HARYANA VIDYUT PRASARAN NIGAM LIMITED

Memo No.-Ch-09/TSG-595

Approval for shifting/re-routing of part section of 66kV S/C Badshahpur-Sector-35 line between TL no. 23 to TL no. 24A from overhead to underground through XLPE power cable infringing the land of M/s Birla Estates Pvt. Limited in Sector-71, Gurugram as a deposit work of M/s Birla Estates Private limited.

FINAL ROUTE FOR SHIFTING OF 64 KV SEC BRUSHMABIR, SEC-36 LINE BETWEEN TL NO 23 TO TL NO 24A DUE TO INFRINGING THE LAND OF MS BIRLA ESTATE PVT. LTD.

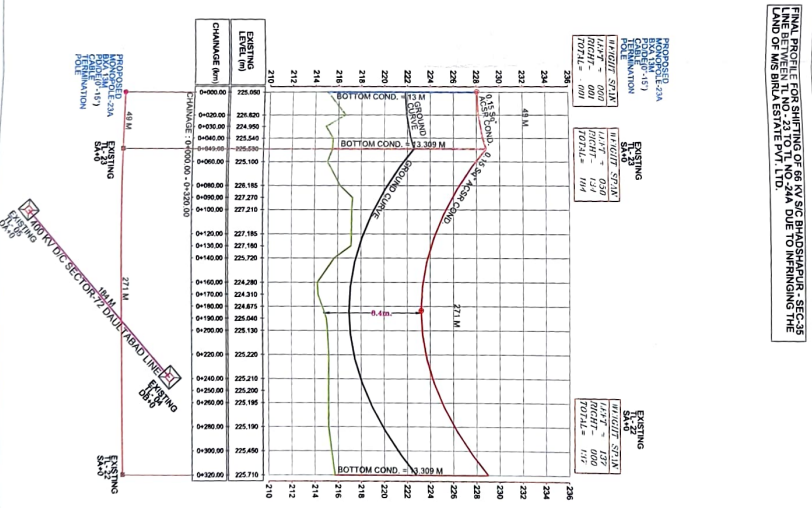
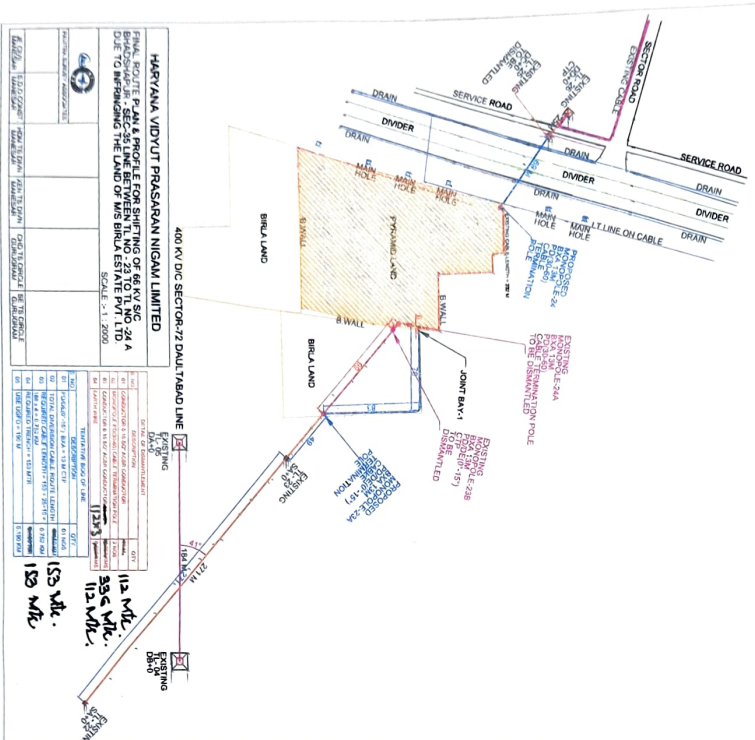
In view of the above, the final route plan for above mentioned work submitted by your office vide memo no. Ch-07/Birla, dated 05.05.2024 has been examined & approved by this office.

1. All clearance w.r.t. buildings, ground, transmission lines and other existing structures would be maintain as per I.E rule.
2. It may be ensured that R.O.W do not infringe forest land being environment issue. If so required clearance be obtained immediately.
3. The requisite approval from local bodies /HSIIDC/ NHAI /GMDA /GAIL /DMRC/IOCL etc. wherever required be obtained immediately by the GMDA, so as to avoid hindrance while construction of line.
4. The requisite ROW shall be arranged by the firm with all time access of the site to HVPNL for maintenance/modification work from future perspective.
5. All the dismantled/spare material i.e. Monopole/cable etc. if any shall be handed over to HVPNL.
6. Turning radius of XLPE cable mentioned in route plan of minimum 20D be maintained.
7. While laying the cable, follow all electricity clearance as per IE rules.
